## UPGRADES TO CHESTNUT ROAD PUMP STATION

Project No. 14947E

### ADDENDUM NO. 2 – December 7, 2015

**ELECTRICAL RISER DIAGRAM**  
 SCALE: NONE

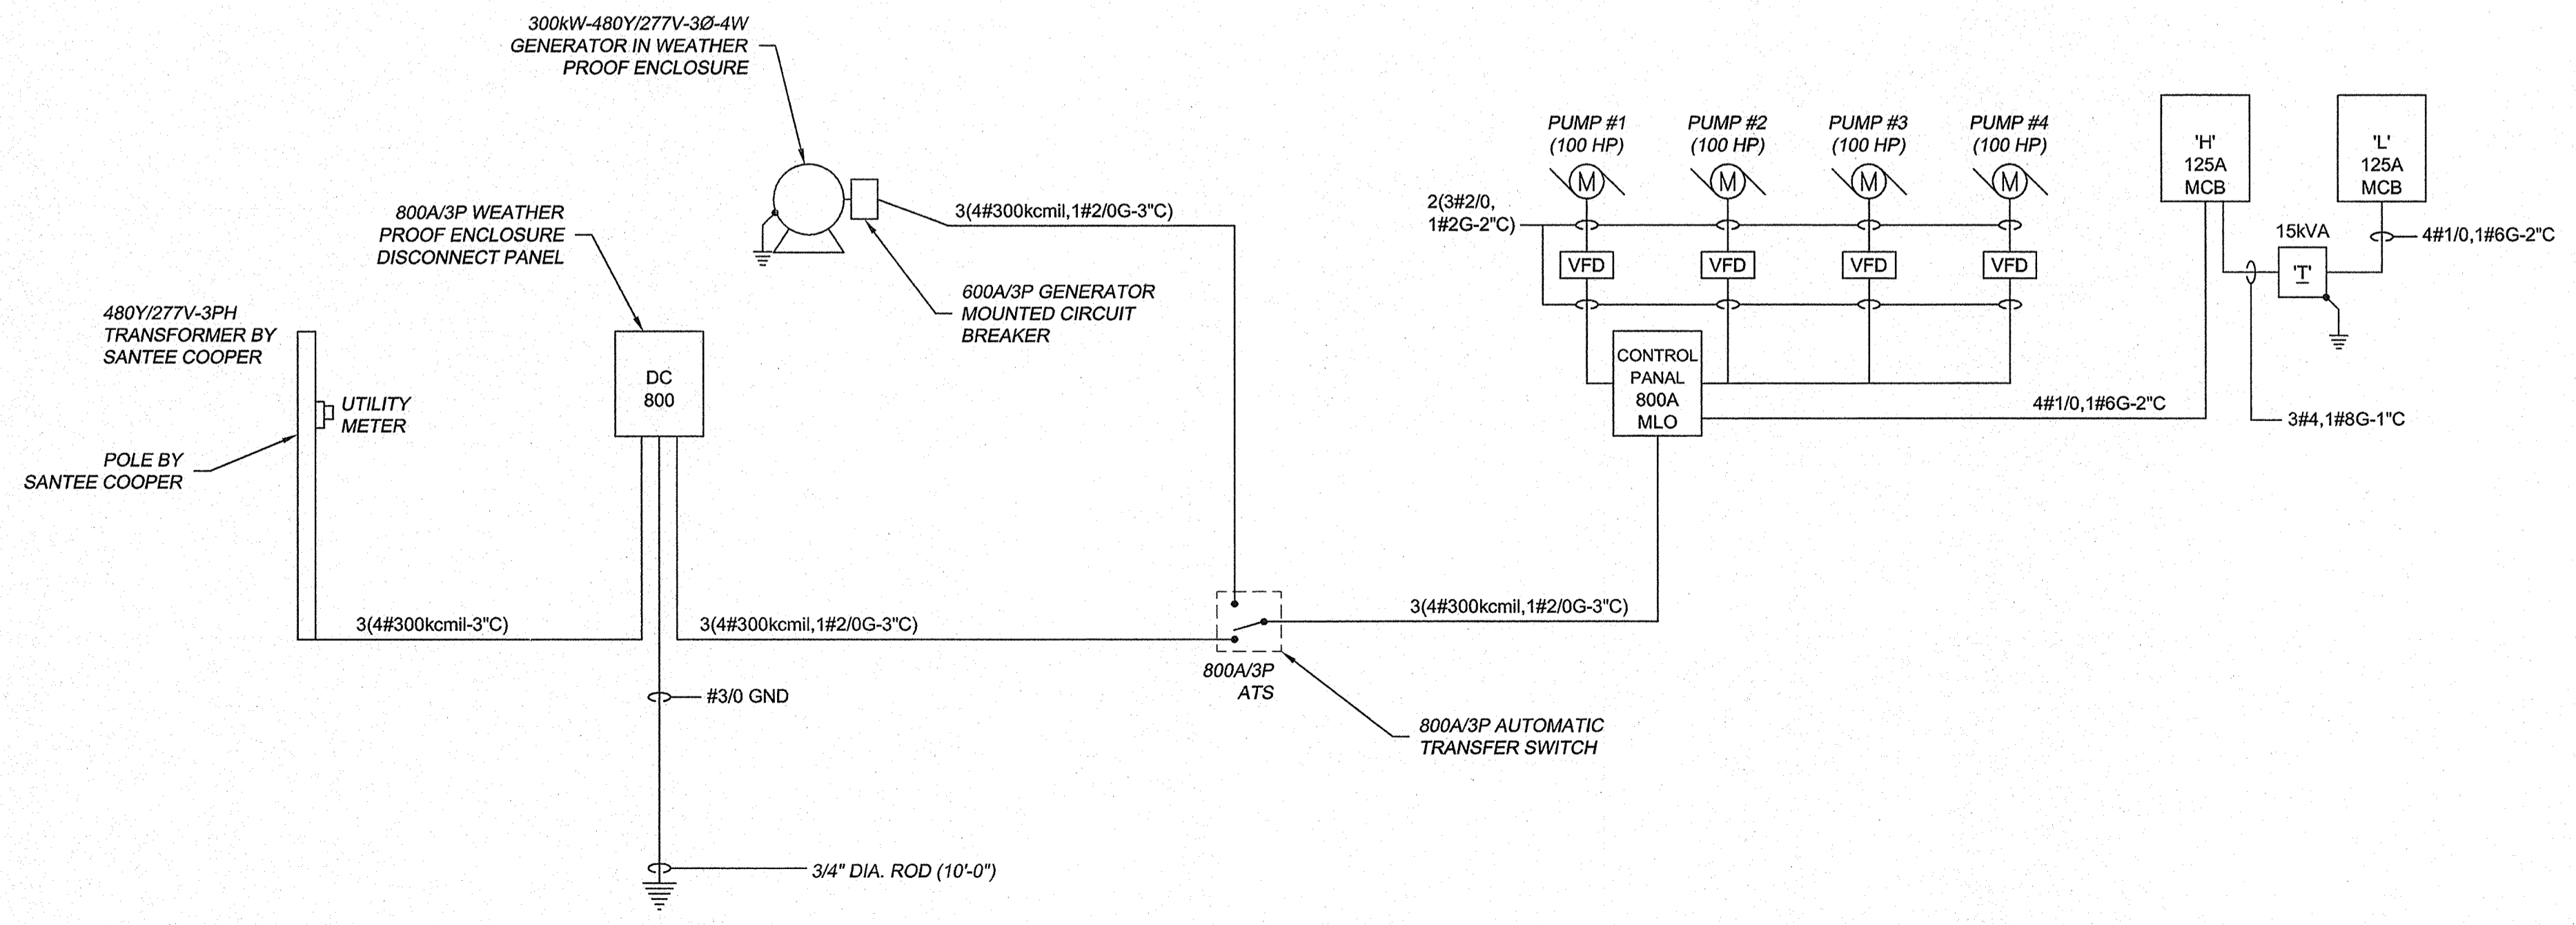
9.0 Please provide detailed Electrical Drawings showing specific details of switchgear, wiring requirements, conduit runs, etc.

***Answer: Please see attachment.***
